THEODORE SWITCHING STATION SUBDIVISION

APPLICATION NUMBER 7 DATE May 5, 2016

APPLICANT Theodore Switching Station Subdivision

REQUEST Subdivision

DETAIL SITE PLAN

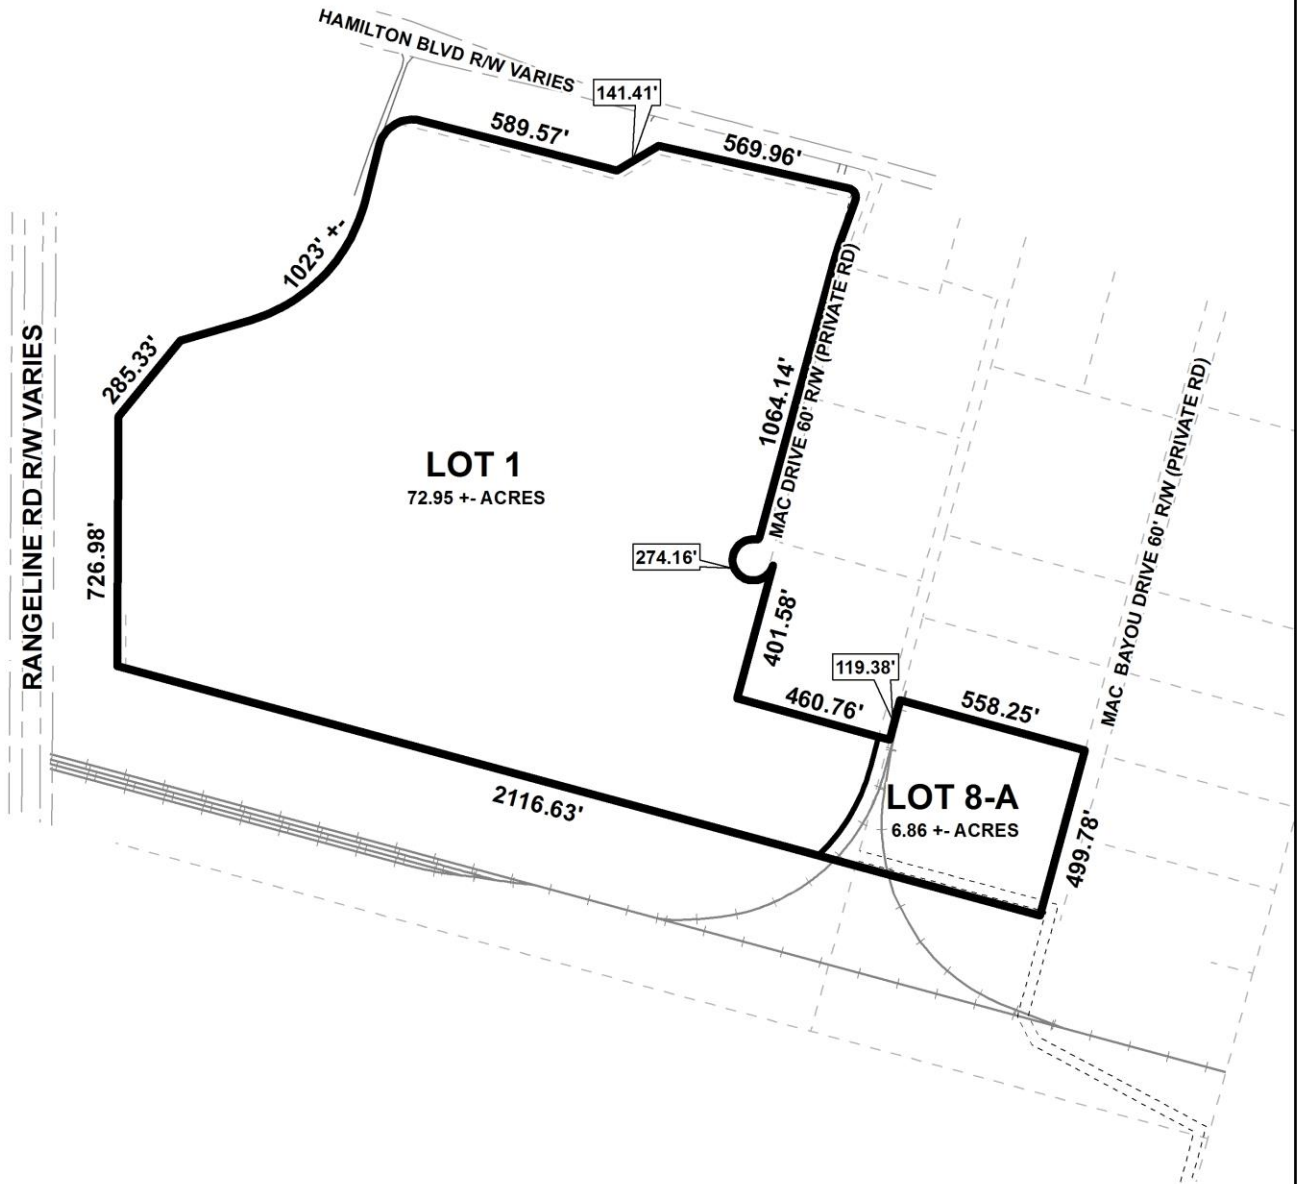
- A. Provide all of the required information on the SUBDIVISION PLAT (i.e. signature blocks, signatures, certification statements, written legal description, required notes, legend, scale, bearings and distances) that is required by the current Alabama State Board of Licensure for Professional Engineers and Land Surveyors.

- B. Delete the three (3) Notary Public statements for the City of Mobile Planning Commission, City Engineer, and Traffic Engineer.
- C. Revise the notary public statement for the Owner to include the entire subdivision name without any abbreviations.

- D. Provide a written legal description for the proposed subdivision.
- E. Provide FEMA flood zone information.
- F. Proposed Lot numbers are LOT 1 and LOT 8A. LOT 8A should be renumbered to LOT 2.

- G. Show and label each and every Right-Of-Way and easement. GIS shows existing public ROW at the SE corner of Lot 8A (Alabama State Docks Service Rd).

- H. Show the complete parcel number instead of a partial parcel number.
- I. The City of Mobile GIS data shows a potential for wetlands on the property. On the plat, show the location of any wetlands, or submit a written statement from a Wetlands Professional stating that there are no wetlands present on-site.

- J. Provide the Surveyor's, Owner's (notarized), Planning Commission, and Traffic Engineering signatures.
- K. Add a note to the SUBDIVISION PLAT stating that a Land Disturbance permit will be required for any land disturbing activity in accordance with Mobile City Code, Chapter 17, Storm Water Management and Flood Control); the City of Mobile, Alabama Flood Plain Management Plan (1984); and, the Rules For Erosion and Sedimentation Control and Storm Water Runoff Control.

- L. Add a note to the SUBDIVISION PLAT stating that as shown on the 1984 aerial photo (FLIGHT 24 - #96 and FLIGHT 25 - #94) the Lot(s) will receive NO historical credit of impervious area towards stormwater detention requirement per Mobile City Code, Chapter 17, Storm Water Management and Flood Control).

- M. Add a note to the Plat stating that the approval of all applicable federal, state, and local agencies (including all storm water runoff, wetland and floodplain requirements) will be required prior to the issuance of a Land Disturbance permit.

The 25' minimum building setback line is indicated only along Hamilton Boulevard on the preliminary plat. The plat should be revised to indicate a 25' minimum building setback along all street frontages, both public and private. A 140' Alabama Power Company easement is indicated along the entire Southern boundary within the site, and various other easements for ingress/egress and utilities are indicated. Therefore, a note should be required on the Final Plat stating that no structures can be constructed or placed within any recorded easements on the site.

- 1) submission and approval of a Rezoning application to eliminate the split-zoning on Lot 8-A prior to signing the Final Plat;
- 2) submission and approval of an Administrative Planned Unit Development application for shared access onto Mac Bayou Drive, a private street, prior to signing the Final Plat;

- 3) submission and approval of a Planned Unit Development application to amend the previously approved Planned Unit Development for MAC Business Park to allow Lot 1 to share access to Mac Drive, a private street, prior to development;

- 4) retention of the labeling of both lots in both square feet and acres, or the furnishing of a table on the Final Plat providing the same information;

- 5) revision of the plat to indicate the 25' minimum building setback line along all street frontages, both public and private;
- 6) placement of a note on the Final Plat stating that no structures can be constructed or placed within any recorded easements;
